**CALL-IN INQUIRY TO CONSIDER LANCASHIRE COUNTY COUNCIL'S APPLICATION  
FOR PLANNING PERMISSION IN RELATION TO THE CONSTRUCTION OF THE  
HEYSHAM TO M6 LINK**

**PROOF OF EVIDENCE**

**DAVID LEVERSEDGE, CAPITA SYMONDS**

**ON BEHALF OF LANCASTER AND MORECAMBE COLLEGE**

Figure 1

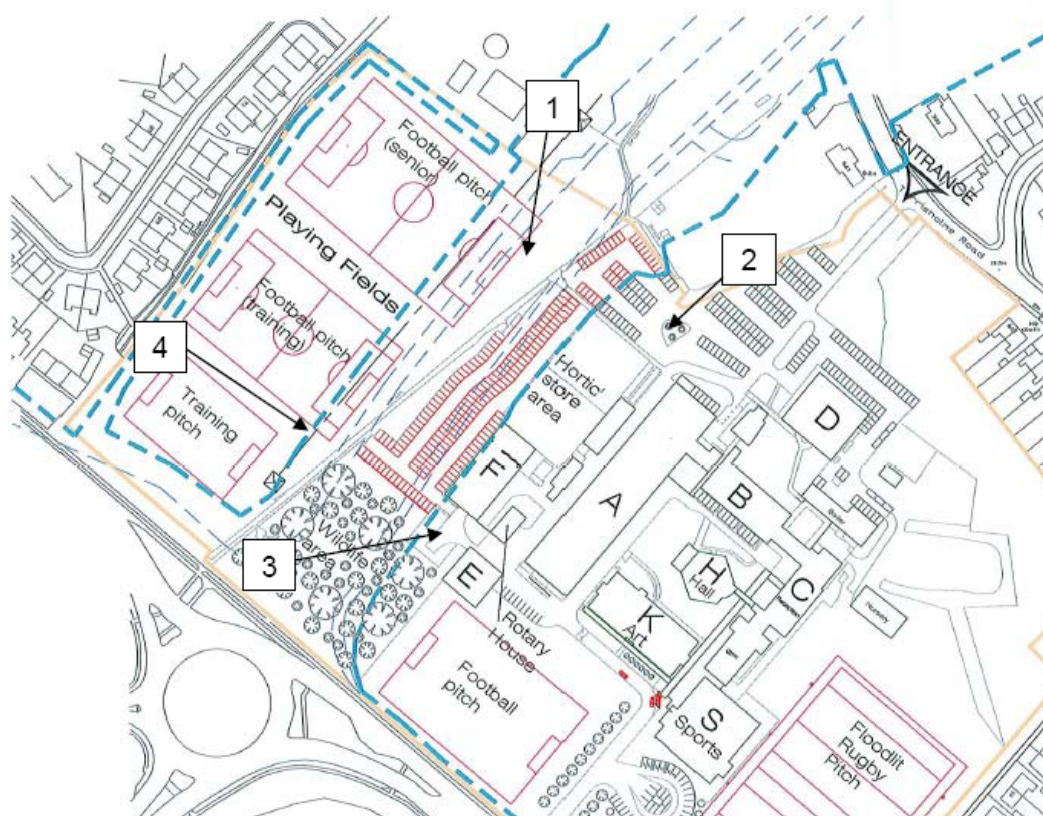
- 5.2 The results show that on the football pitches closest to the A589 and thus currently experiencing the highest noise levels, the levels are all below the WHO guideline level of  $L_{Aeq}$  55 dB for outdoor playgrounds. It is understood that these pitches, when not in use for sport related activities are also used for external lessons for trades.

- 5.3 The highest noise levels were measured at the western elevation of Building E (Position 3) where a level of  $L_{Aeq}$  57.4 dB was recorded. Allowing for an attenuation of between 10 and 15 dB from a window open for ventilation, as offered as guidance in BS8233:1999 and reported in Table 2 above, the current internal noise level within these classrooms is between  $L_{Aeq}$  47.4 and 42.4 dB and with the single glazed windows closed between  $L_{Aeq}$  35.4 and 27.4 dB.

- 5.4 Thus with the windows closed, a 'good' standard of internal ambient noise level as defined in BS8233:1999 is currently achieved, and the WHO guideline value is also achieved.

Figure : Noise Mapping Prediction Points

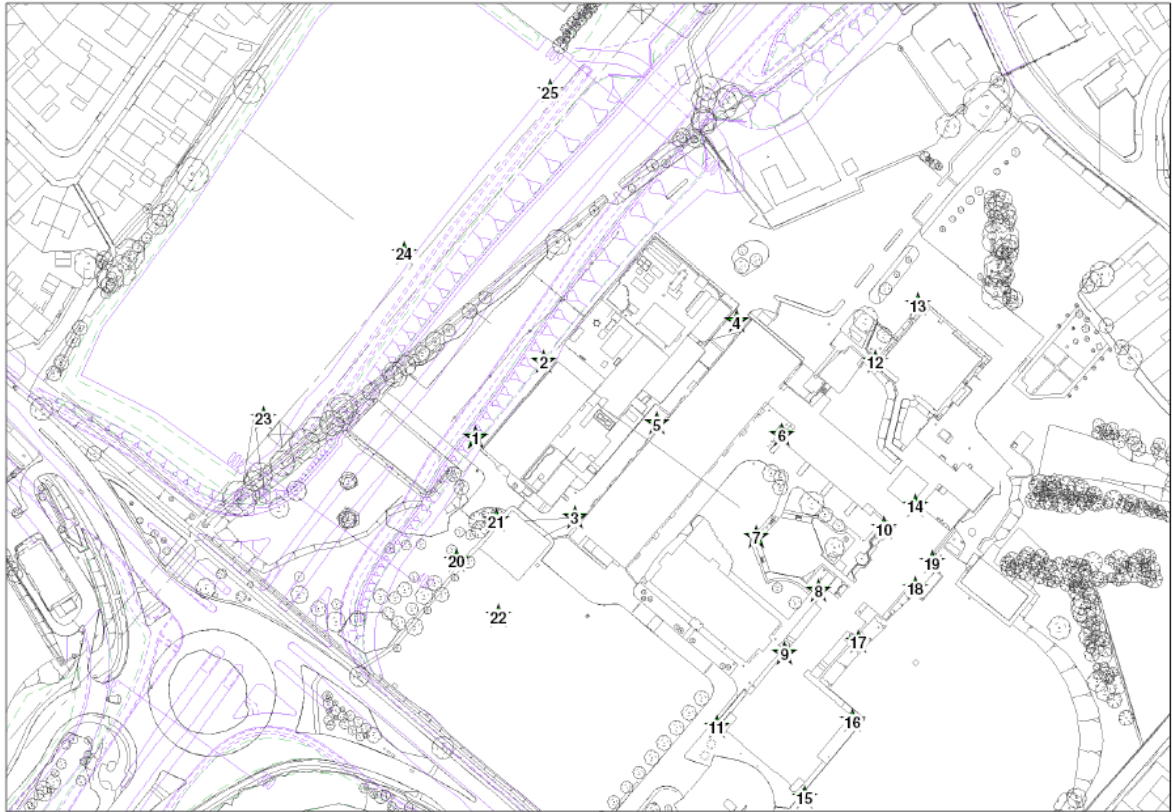
- 6.9 From Table 3 it can be seen even when the mitigation from the roadside noise barriers has been applied, there are substantial residual impacts across the College campus at Buildings A, B, D and F and on the pitches. Increases in road traffic noise in these locations will be noticeable to persons in these areas, and will require persons in these areas to speak more loudly to one another than at present outside these buildings.

- 6.10 At receptor locations 24 and 25 which represent part of the area used as playing fields, noise levels are predicted to exceed  $L_{Aeq} 55\text{ dB}$ , the level which the WHO guidelines have determined as the level which should not be exceeded in outdoor playgrounds which will include playing fields. These increases in the ambient noise levels in on the playing fields which as well as being used for sports activities in association with the Sports Academy of the College are also used for outdoor lessons for Distributive Trades classes produce a noise climate where vocal communication will not be as good as it is currently and exceeds the WHO Guidelines, once again requiring persons in these areas to raise their voices when speaking to one another.

- 6.11 The substantial predicted increases at the external facades of 4 out of the eight campus teaching buildings assessed, that is Buildings A, B, D and F, have been examined further to determine what the impact would be on internal ambient noise levels. The of  $L_{Aeq} 35\text{ dB}$  which the WHO Guidelines state should not be exceeded during teaching sessions and BS8233:1999 gives a range of between  $L_{Aeq} 35\text{ dB}$  for 'good' and  $L_{Aeq} 40\text{ dB}$  for 'reasonable'. The predictions show that the  $L_{Aeq} 35\text{ dB}$  level is exceeded over part of the range allowed for attenuation from closed single glazed windows in Table 2 of my evidence, and there is a substantial increase in indoor ambient
